From: Olvera,Brandon
Sent: Tuesday, April 30, 2024 4:04 PM
To: Greg Johnson
Cc: Brad Parker
Subject: RE: 1896 LIVE OAK DR - HUERTA #11

APPLICATION FOR PERMIT FOR AUTHORIZATION TO CONSTRUCT AN ON-SITE SEWAGE FACILITY AND LICENSE TO OPERATE

RE: Septic Design #117346
1896 Live Oak Drive
Tamarack Shores, Section 2, Lot 93
Canyon Lake, TX 78133
Huerta Residence

OWNER: MICHAEL & DOLORES HUERTA		DRAWN BY: EJS III	
STREET ADDRESS: 1896 LIVE OAK DRIVE			
LEGAL DESC: TAMARACK SHORES	UNIT/SECTION/PHASE: 2	BLOCK:	LOT: 93
PREPARED BY: GREG W. JOHNSON, P.E. F#002585	SCALE: 1"=20'	DATE: 1/18/2024	2nd REVISION: 4/24/2024

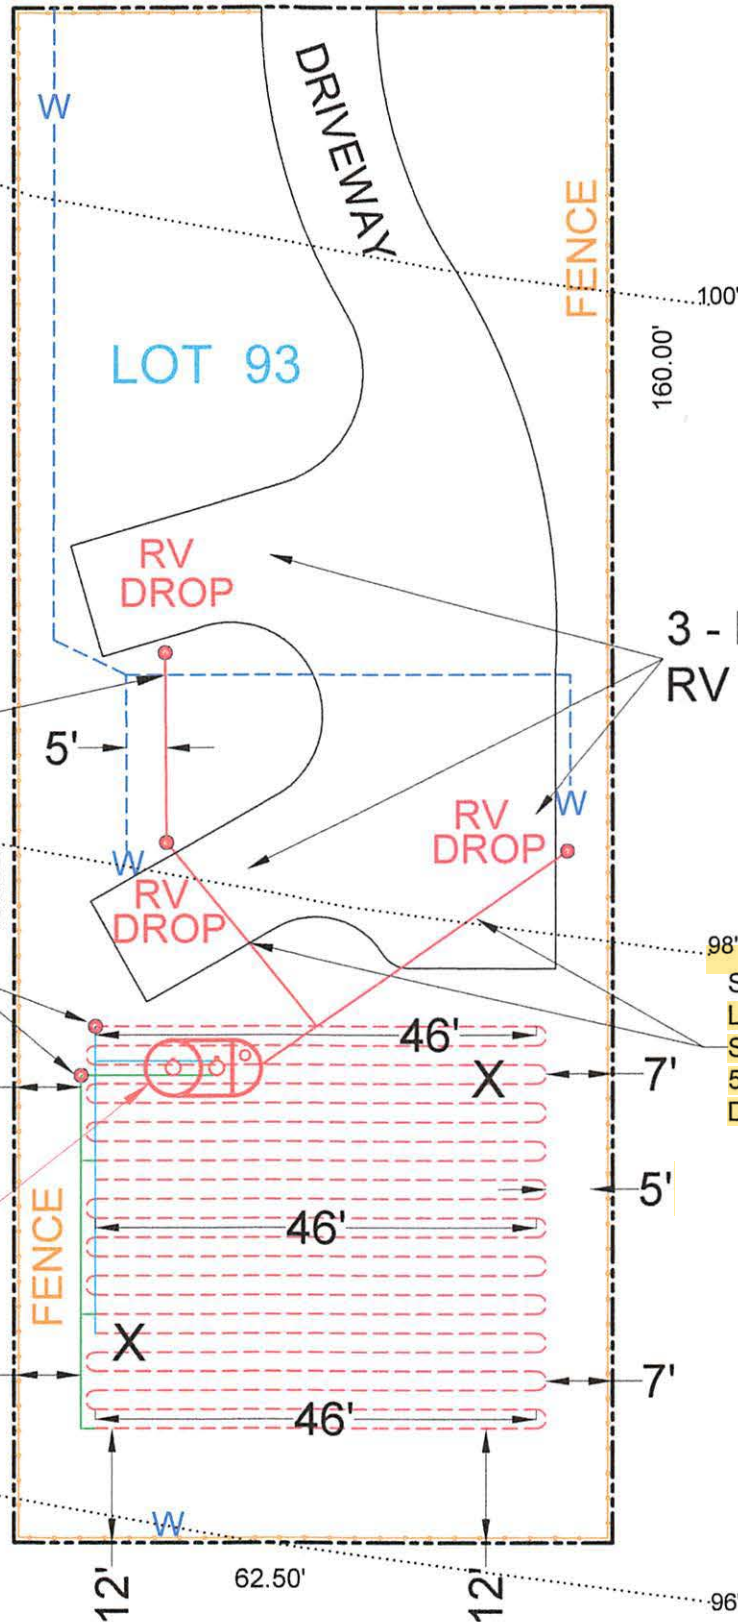
A portion of the waterline is as close as five feet from the proposed drip field. A variance is required to Chapter 285 Table X & 290.44(e)(8). Equivalent protection will be maintained by sleeving the water service line with SCH-40 PVC within ten feet of the proposed drip field. I hereby request a variance to Chapter 285 Table X & 290.44(e)(8).

INSTALL 2024sf OF FIELD USING 1012' OF DRIP TUBING. THERE SHALL BE NO PARKING, DRIVING OR STORAGE ON THE SEPTIC FIELD AT ANY TIME FOR ANY REASON.

SLEEVE WATER LINE WITH 2"-SCH-40 PVC PIPE WHEN ENTERING CLOSER THAN 10' FROM SEPTIC SYSTEM OR SEPTIC FIELD WHICH EXCEEDS TAC 30 CHAPTER 290.44(e)(B)(i).
